City of Richmond
Urban Development Division

General Compliance Request

To: Development Permit Panel
From: Joe Erceg
Manager, Development Applications
Date: December 16, 2003
File: DP 03-244583
Re: **Application by J.A.B. Enterprises Ltd. for a General Compliance request at
7060 Blundell Road**

SITE PLAN
SCALE 1:500

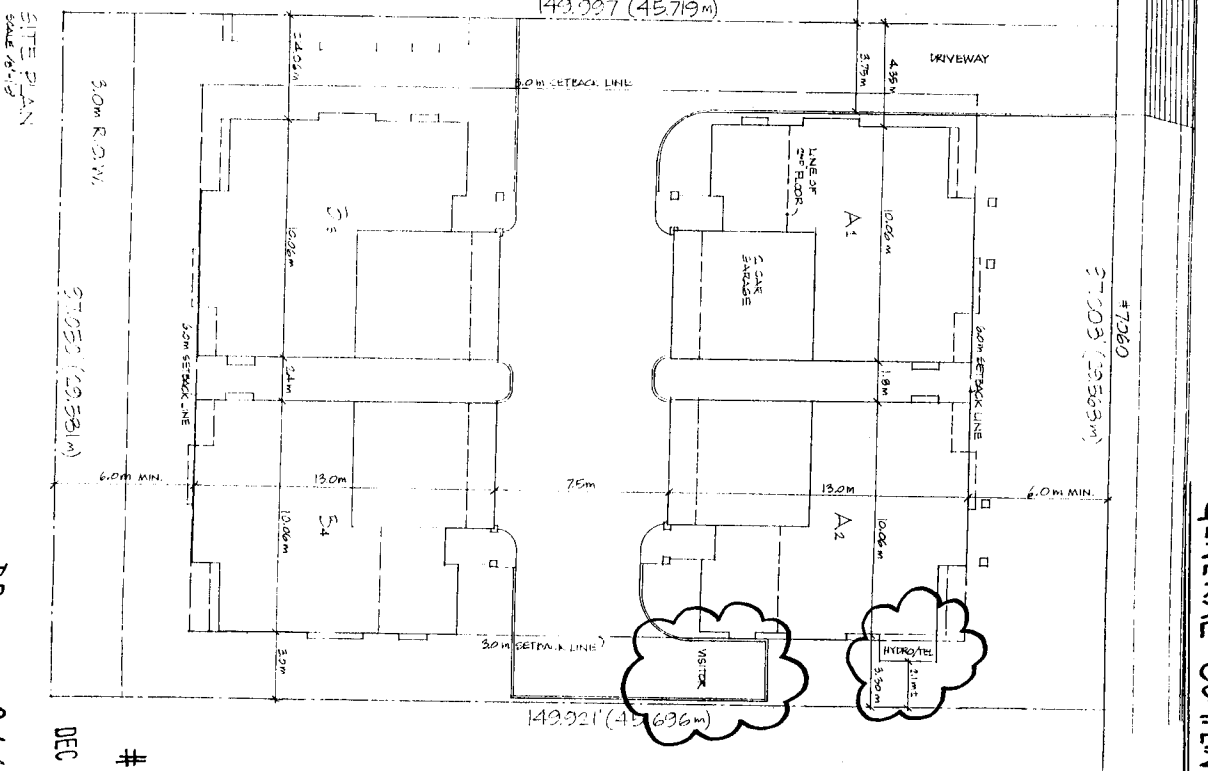
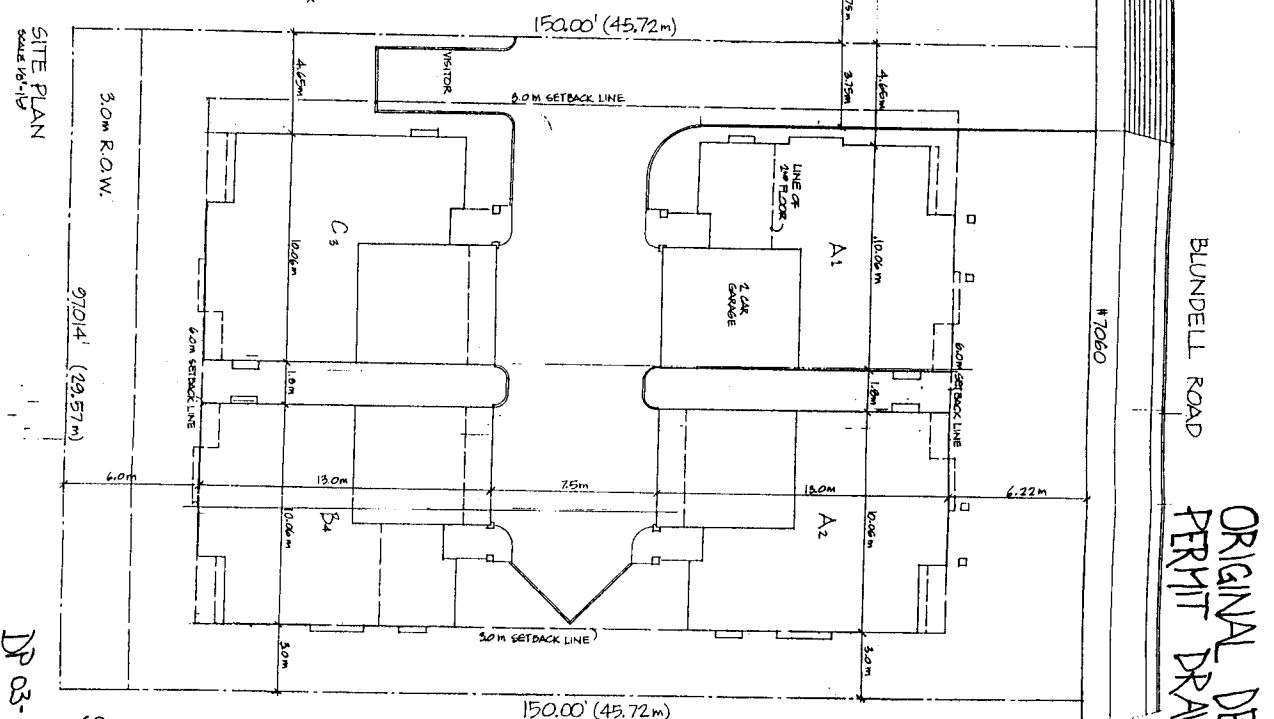
That the addition of a hydro utility enclosure room projecting 0.9 m (2.95 ft) into the side yard setback and relocation of one (1) visitor parking stall be considered in General Compliance with Development Permit DP 03-244583 at 7060 Blundell Road.

A proposed utility enclosure room containing hydro meters is being added at the north-east corner of the subject site and will be attached to one (1) of the townhouse units. This utility enclosure room projects 0.9 m (2.95 ft) into the side yard setback. The developer and designer are also proposing to relocate one (1) visitor parking stall to an area north of the laneway near the east property line. A General Compliance ruling is being requested for these proposed changes.

7. Proposed changes to the location and configuration of vehicle access and parking areas should be minor in nature. ***The applicant has acquired the neighbouring lot to the west (7040 Blundell Road) and is consolidating both properties and adding three (3) additional townhouse units. The visitor parking is being relocated to allow development on this site, while maintaining visitor parking requirements stated in Zoning and Development Bylaw 5300. Driveway and vehicle access is unchanged.***

B.C. Hydro requested that a service enclosure be added after issuance of the Development Permit. This request has resulted in the encroachment of a utility enclosure room into the required side yard setback. There is a precedent for treating utility room projections in similar situations through a General Compliance ruling rather than a Development Variance application. In past circumstances where B.C. Hydro has requested service meters to be relocated (where the developer has no control over this), our Law Department and previous Development Permit Panels have agreed that these situations are best dealt with by a General Compliance ruling.

Permitting the projection of the hydro enclosure room into the side yard setback through a General Compliance ruling avoids having to adjust the driveway access easement due to a shift in two (2) buildings to accommodate the utility enclosure room. Building Approvals staff indicate that no Building Code issues arise so long as the enclosure is maintained at a minimum distance of 1.2 m (4 ft) from the east property line.

UTILITY ENCLOSURE

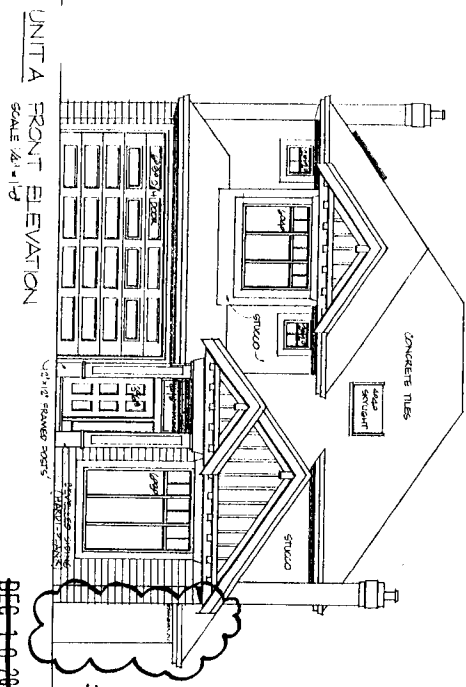
4. Proposed exterior modifications must maintain or enhance the quality of the development and must retain the basic form and character of the development. ***A small utility service enclosure is being added on the townhouse unit at the north-east corner of the subject site that does not impact the form and character of the development.***
